SERVICE BULLETIN

#0032

MODELS AFFECTED: **Sling 4 HW:**

SUBJECT: Replacement of Pedal Bellcrank and Brackets

Figure 1. Centre Console Skin to be Removed.

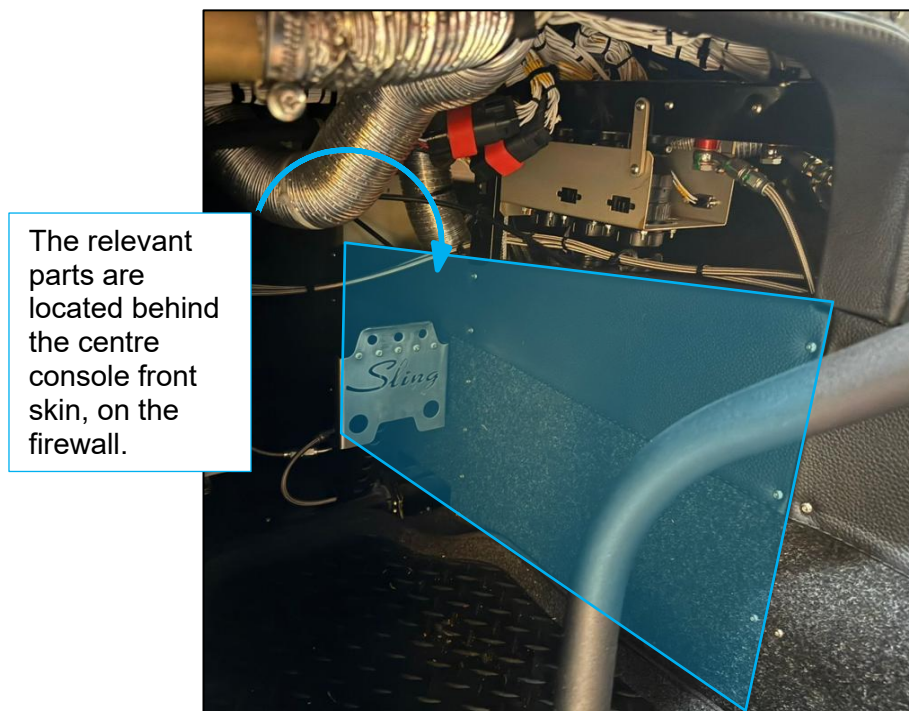
- Step 1: Remove the Centre Console Front Skin (Right or Left) to gain access to the bellcrank and brackets.

Figure 4. Rivets to be Drilled Out.

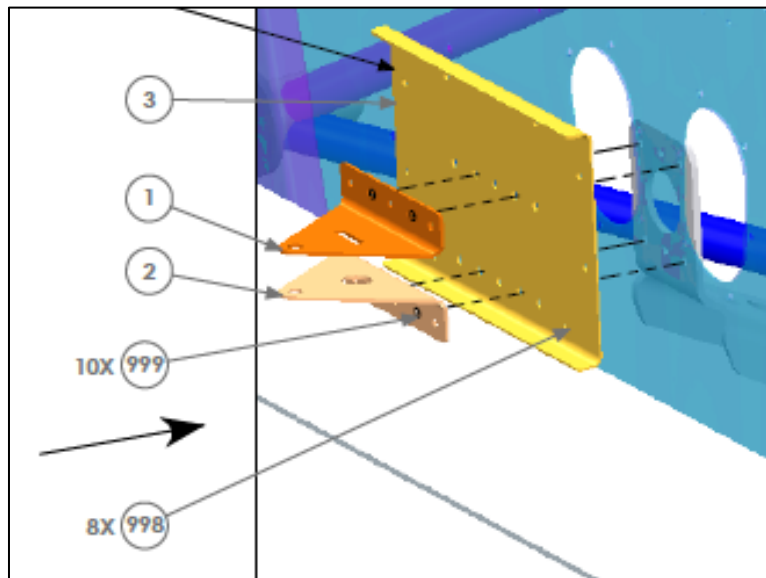
Step 4: Drill out the rivets securing the brackets and *Bellcrank Firewall Forward Mounting Channel* (Item 3 in the figure below). Use the relevant drill bits and angle drill for this operation. (Refer to rivets indicated by item 998 and 999 below).

Figure 6. New Rivet Holes for Brackets.

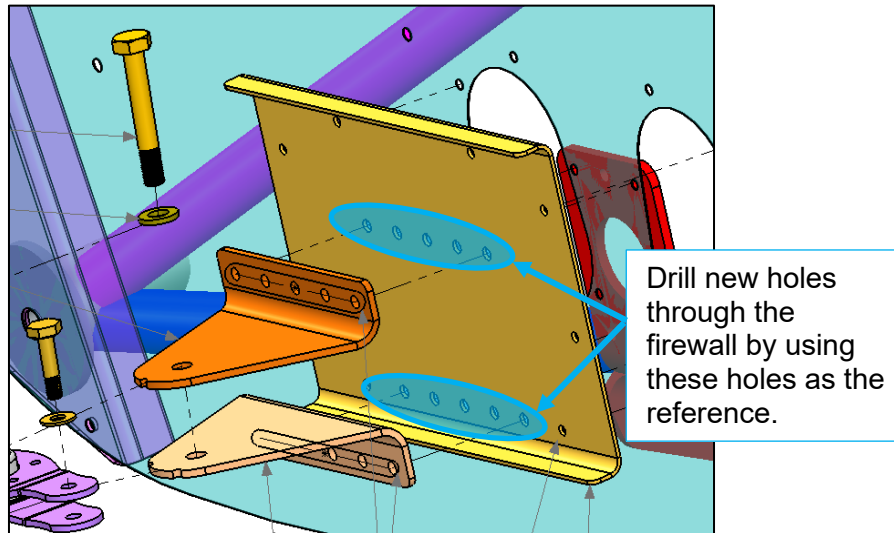
- Step 6: Drill new holes through the firewall for the updated brackets, as per the instructions in the construction manuals referenced under section 1.4 of this document.
Use part *CF-CHL-058-C-I (Bellcrank Firewall Forward Mounting Channel)* as a template to drill the new holes.
The new brackets are spaced 13mm further apart than the old brackets. Thus, the holes through the firewall won't line up with the holes in the updated part *CF-CHL-058-C-I* and new holes will need to be drilled. The specific holes mentioned here are shown in the figure below.
